STAFF REPORT

SUBJECT: AZ, PP-H-2020-0105
Cache Creek Subdivision

Annexation of 15.18 acres of land from RUT zone in Ada County to the R-4 zone and a preliminary plat consisting of 41 buildable lots and 4 common lots on 13.99 acres in the proposed R-4 zone.

A. Revised Preliminary Plat (date: 12/17/2020)

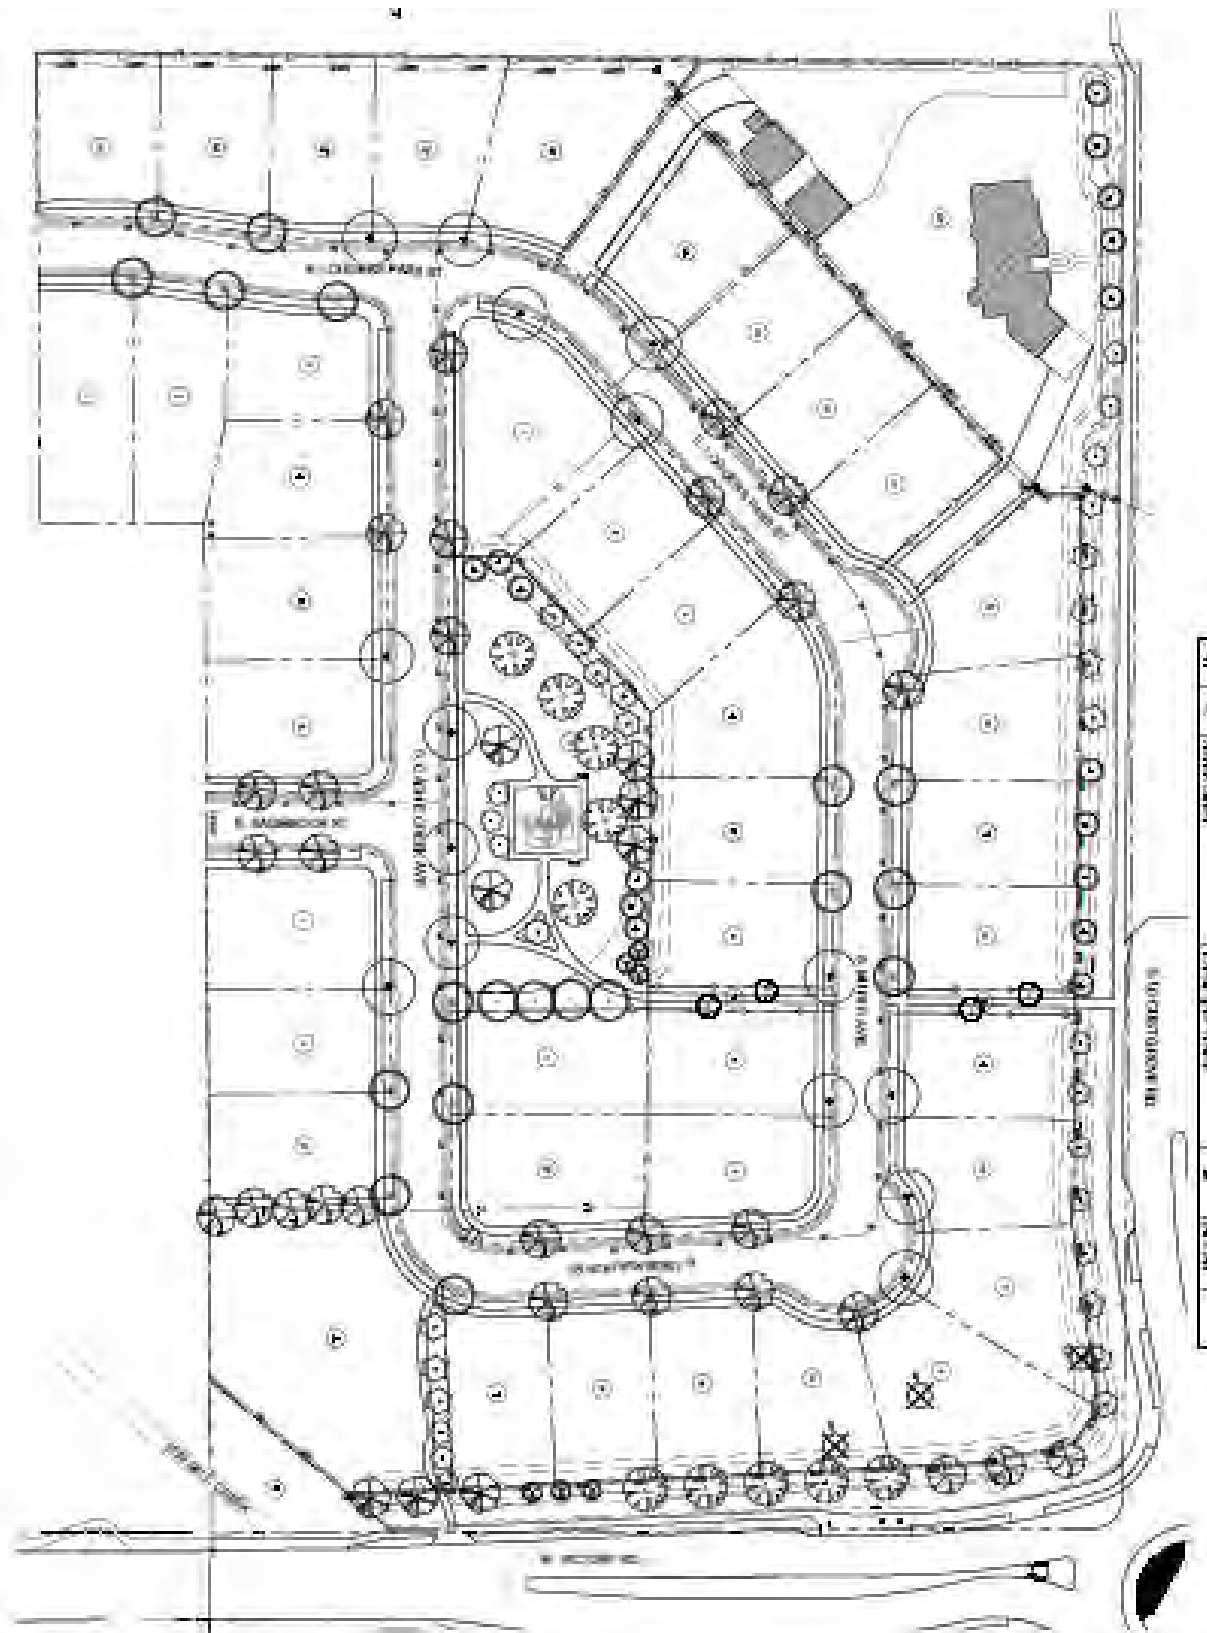
Nampa Meridian Irrigation District (NMID) has mentioned Ten Mile Creek is contained within a 100' irrigation easement, with 50' on either side of the creek. The Plat should be revised to reflect this easement.

6. The Ten Mile Creek Nampa Meridian Irrigation District easement shall be reflected on the Preliminary Plat and Landscape Plan.
7. The applicant shall coordinate with Meridian Parks and Recreation to determine whether signage shall be installed to direct users to the pathway connection paralleling Retention Basin Lot 4, Block 2 to the Ten Mile Pathway to the southwest, and the connection to the Eight Mile Pathway across S. Locust Grove Rd.

9. The Preliminary Plat included in Section VII, dated 10/29/20, is approved with the conditions listed in 3, 4 and 5 and with the addition that Note 6 be revised to include Lots 11 and 12, Block 3 instead of Lots 1 and 3 (regarding common lots).
